RE: **Milani Park – Extended Build-Out**  
**Project #: 080510**  
**TRAFFIC PERFORMANCE STANDARDS REVIEW**

The Palm Beach County Traffic Division has reviewed the traffic statement for the extended build-out date for the previously approved County Park project entitled; **Milani Park**, pursuant to the Traffic Performance Standards in Article 12 of the Palm Beach County Land Development Code. The project is summarized as follows:

Re: **Milani Park – Town of Highland Beach**  
**PCN No. 24-43-47-09-00-001-0050 & 0060**  
**LDS No. 1447.1**

Land Design South (LDS) has reviewed the Special Exception Application Package for the **Milani Park** property. The 5.39-acre Park is located at 4701 South Ocean Blvd, along SR-A1A north of Spanish River Blvd in the Town of Highland Beach, Florida. Parcel Control Numbers associated with this project are 24-43-47-09-00-001-0050 & 0060. Figure 1 shows an aerial location of the site in relation to the transportation network.

Excerpt from Special Exception Application Package – Supplemental Parking Justification.

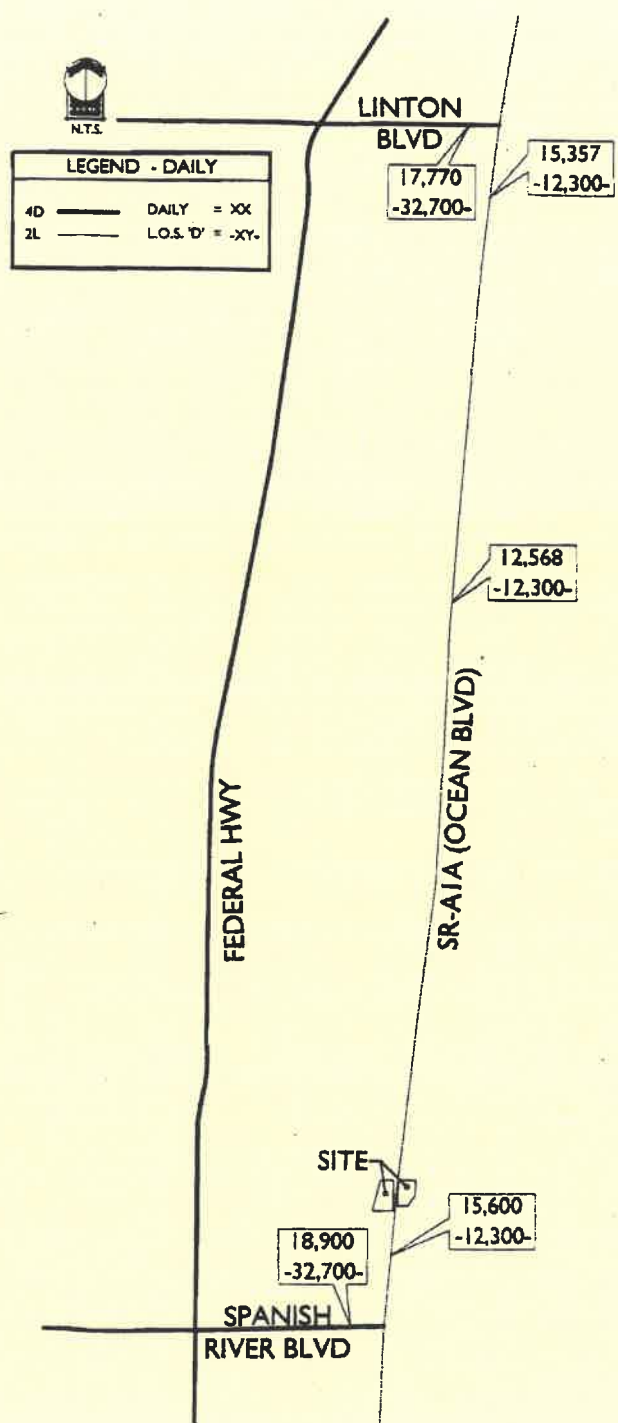
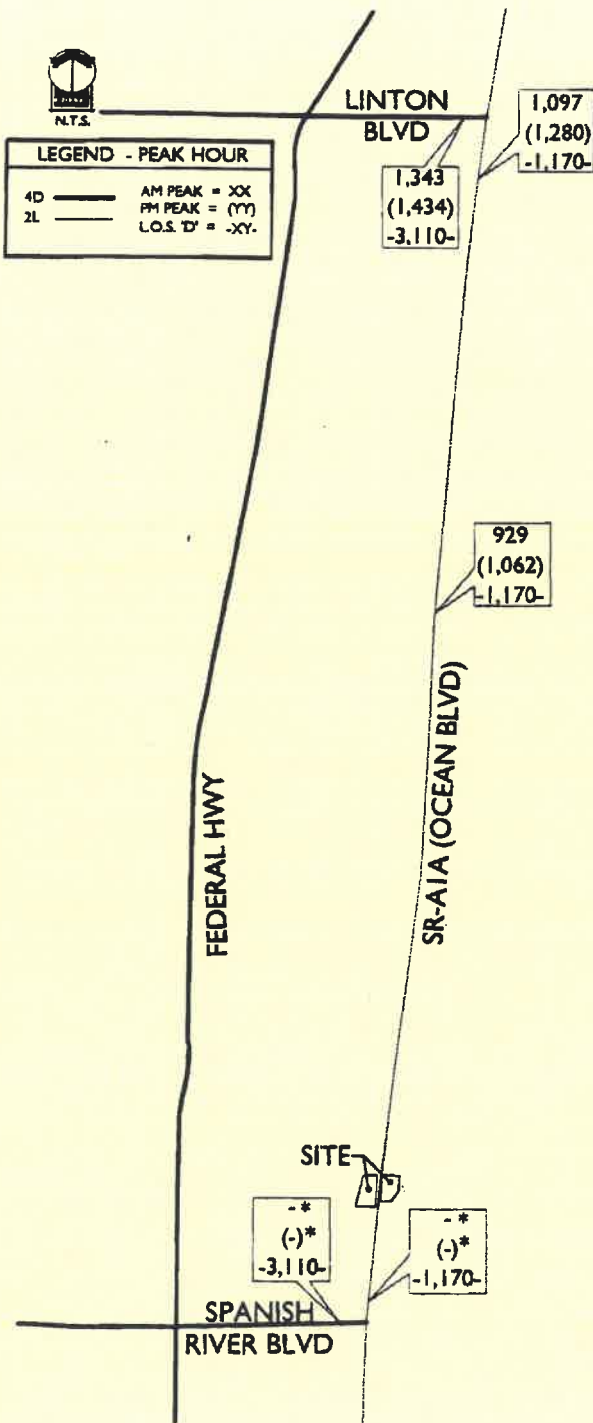
A parking justification to accommodate the expected demand had been submitted as part of the application package for the **Milani Park** property, *Item No. 8: Statement of Plan Compliance – Supplemental Parking Justification* (see enclosure). The *Supplemental Parking Justification* section indicates that 140 parking spaces were considered appropriate at the time of the property purchase in 1987. Based on a phone conversation with the PBC Planning Superintendent from the Parks and Recreation Department, Bill Wilsher<sup>1</sup>, a conceptual site plan was presented at the time of property purchase. The conceptual site plan proposed 140 spaces as the preliminary number and the most efficient layout for the site. The mentioned conceptual site plan was not included as part of this application.

The submitted Site Plan, *Sheet S-1 revised on 9/07/07*, proposes 100 parking spaces. The reduction of parking spaces is explained in the *Supplemental Parking Justification* section as an agreement between the Town and the County. However, copy of the application package for the **Milani Park** received by LDS did not include documentation supporting the mentioned agreement.

Finally, the applicant explained that with 100 parking spaces the County will be in a position to accept as a condition of approval the Town's request of charging a fee for parking. Please note, copy of the application package for the **Milani Park** received by LDS did not include documentation supporting the mentioned Town request. According to the applicant, collecting the fee could be achieved via parking meters charging per hour where a meter maid is required or an attendant booth with a flat rate per day. Regardless of the method of collection chosen, the revenues for 100 parking spaces compared to the annual cost of collecting the parking fees would be close to a break even point. As explained by the applicant, a reduction in parking spaces below 100 may create a negative cash flow situation and the County could not accept the condition of approval from the Town. The applicant supports this documentation by comparing revenues at Kreusler Park in Lake Worth (parking meters) and South Inlet Park in Boca Raton (flat rate).

# 2010 V/C Estimates for Milani Park-Town of Highland Beach

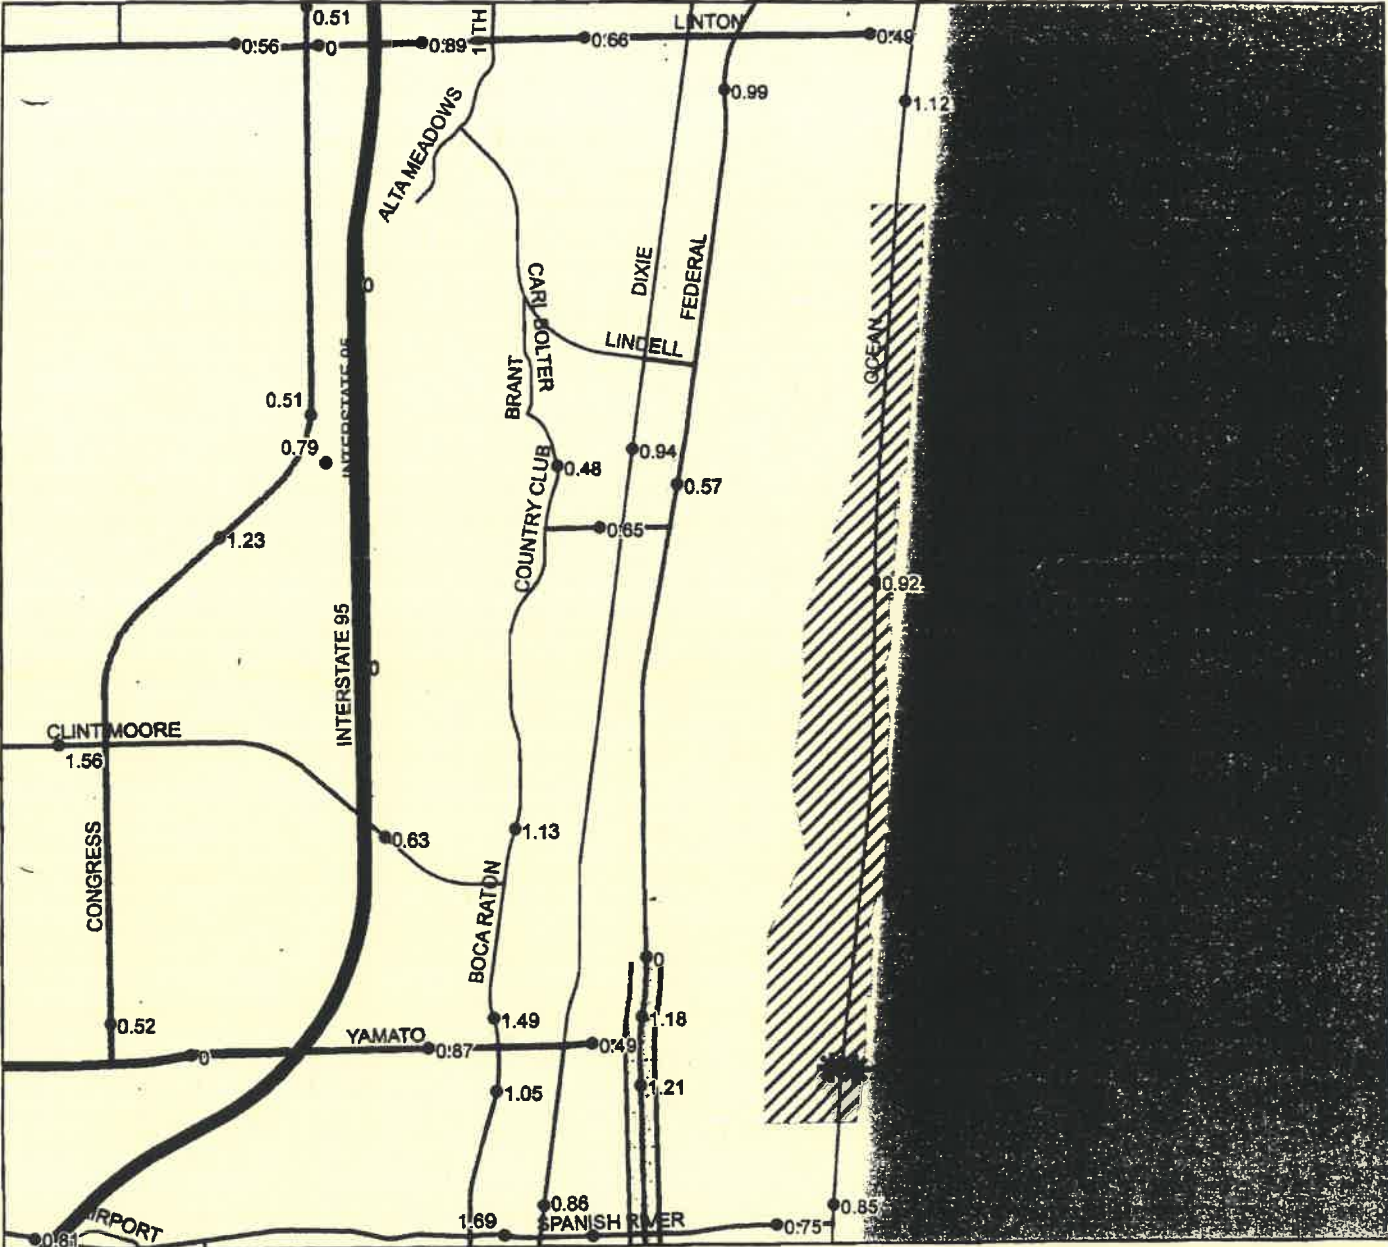
Preliminary analyses for the year 2010 conditions of the project vicinity area were carry-out with Volume/Capacity (V/C) ratios for peak hour conditions. See enclosure for this 2010 V/C Estimates. The V/C ratio provides a preliminary understanding of future conditions at the assumed project build-out in 2010. The enclosed 2010 V/C Estimates figure points out those links that will most likely be over capacity (V/C>1.0) and near capacity in the year 2010. Based on the enclosed 2010 V/C Estimates figure, SR-A1A south of Linton Blvd will be overcapacity in 2010.

Chapter 163.3180(6) of the 2005 Florida Statutes has changed the way *De Minimis* impacts are reviewed and approved. Under the new *De Minimis* methodology even those projects that generate less than 1% of the LOS need to check for V/C ratios, however, *De Minimis* does not apply to all links in PBC. The 2006 De Minimis Link Report for PBC adopted August 27, 2007, published links where *De Minimis* will be enforced. None of the links within the vicinity area are included in the *De Minimis* list. Note that Federal Hwy between Glades Rd and Newcastle St is included in *De Minimis* list as showed in the enclosed 2010 V/C Estimates figure.
